DRAINAGE / CIVIL PLAN
 VALENTIN RESIDENCE
 4350 E. MERCER WAY, MERCER ISLAND, WA 98040

DRAWING NO:
C2.0
 APN 004610-0150
 1902-013

VALENTIN RESIDENCE
4350 E. MERCER WAY, MERCER ISLAND, WA 98040

DRAWING NO: C3.5
APN 004610-0150
1902-013

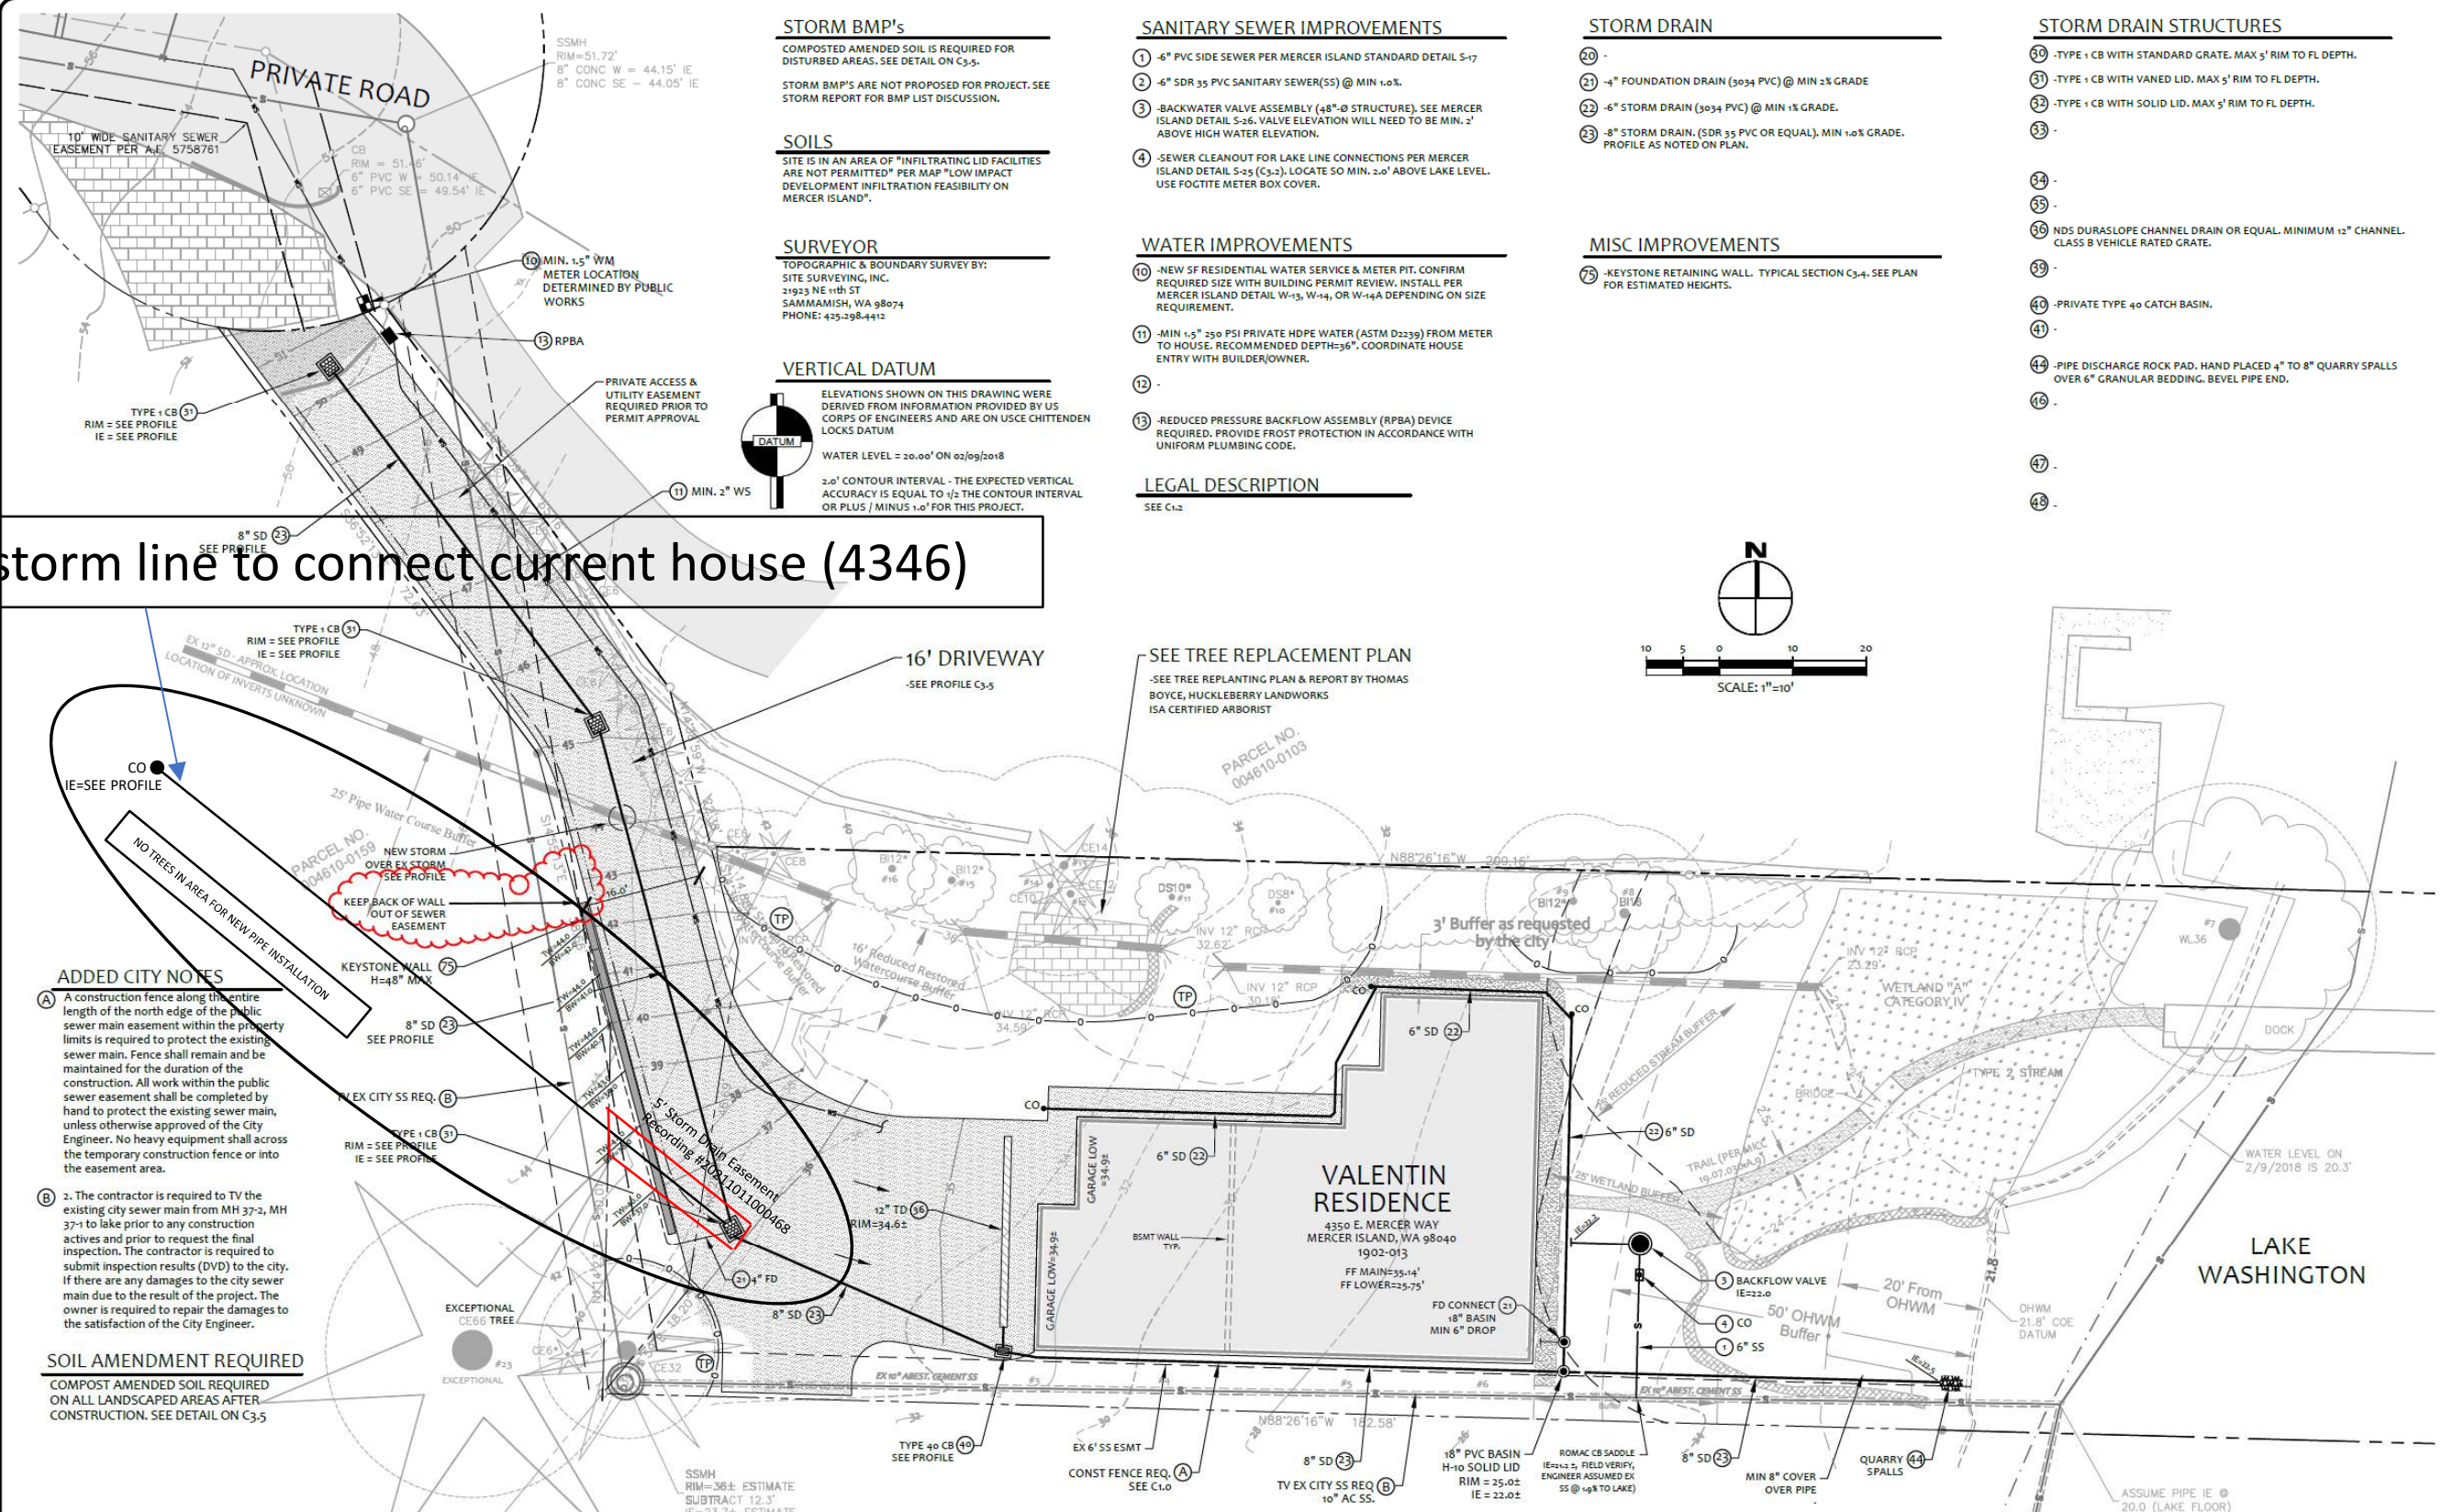
Add 6" storm line to connect current house (4346)

PRIVATE DRIVEWAY / STORM PROFILE

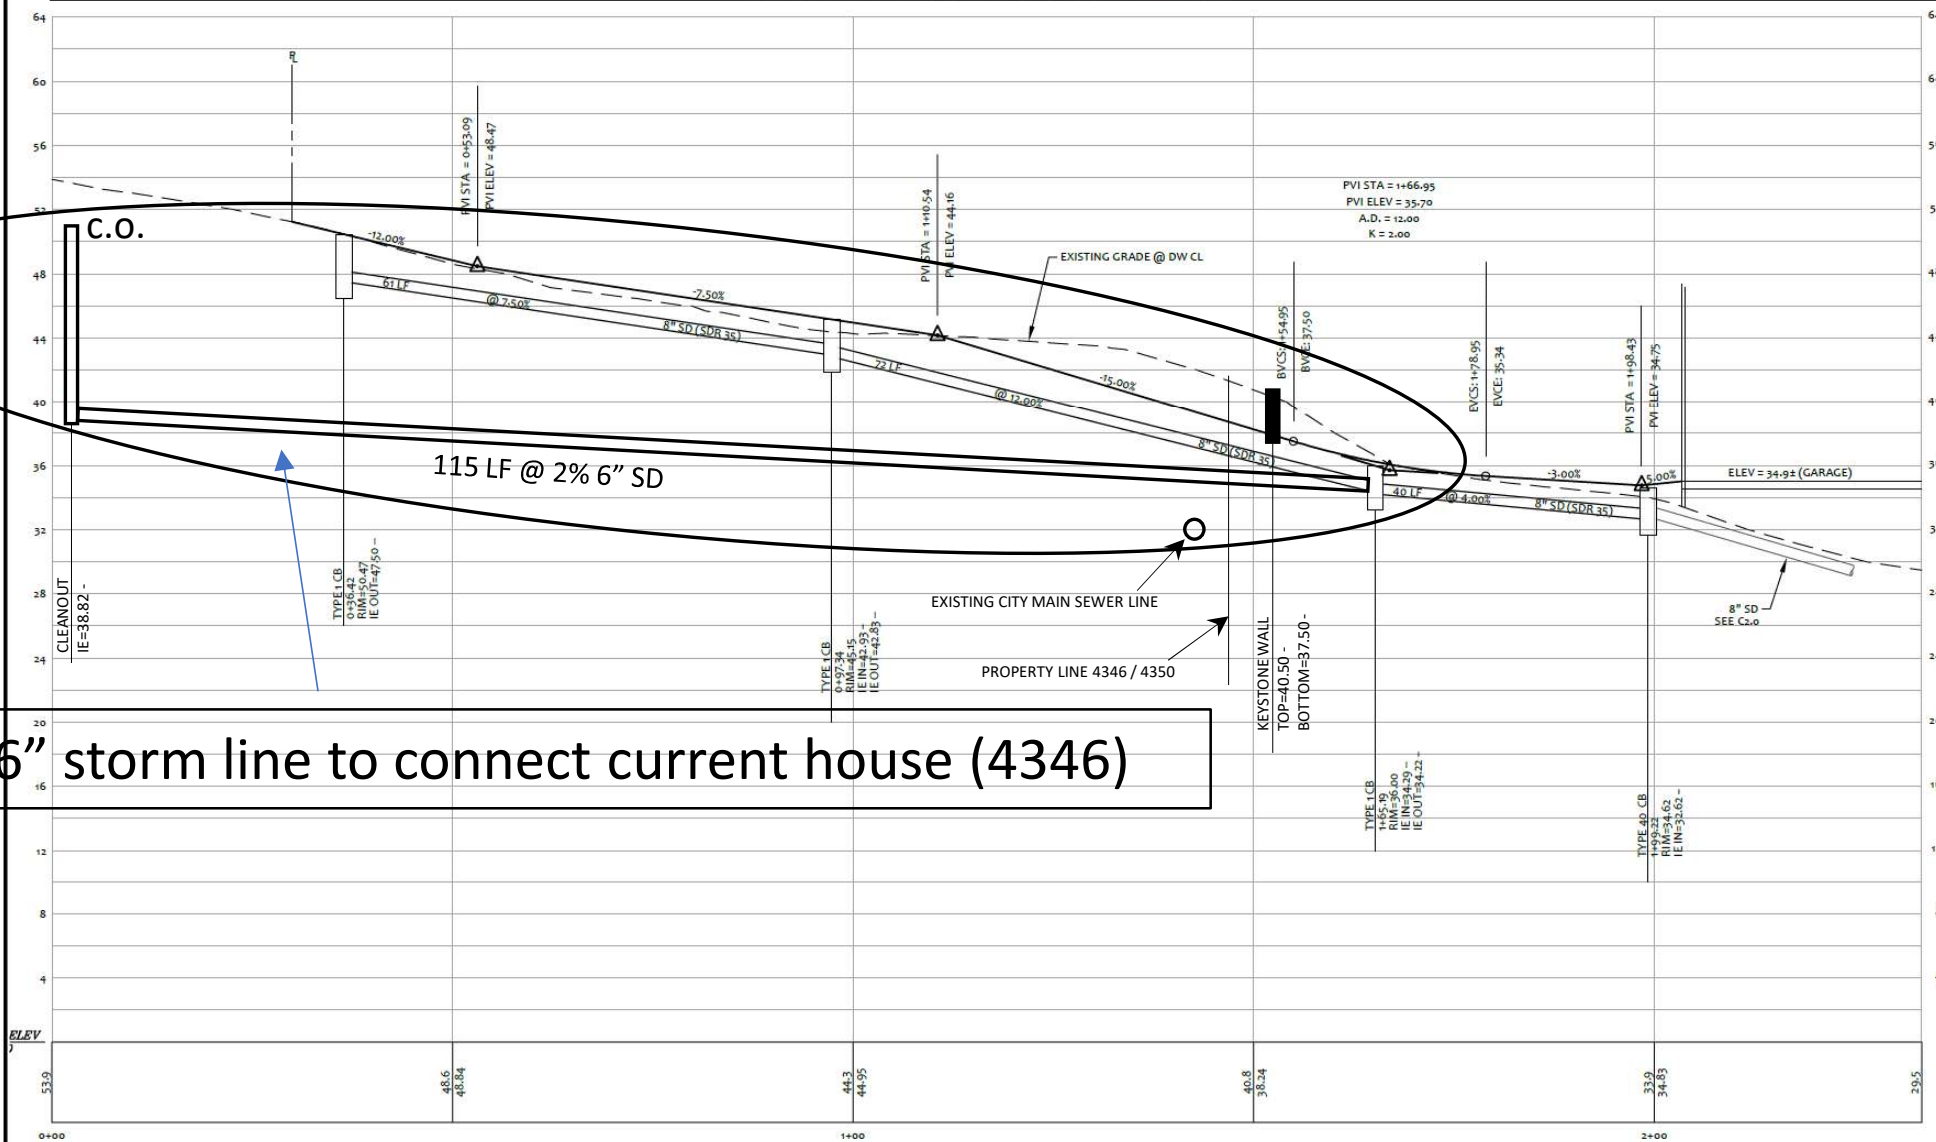
Add 6" storm line to connect current house (4346)
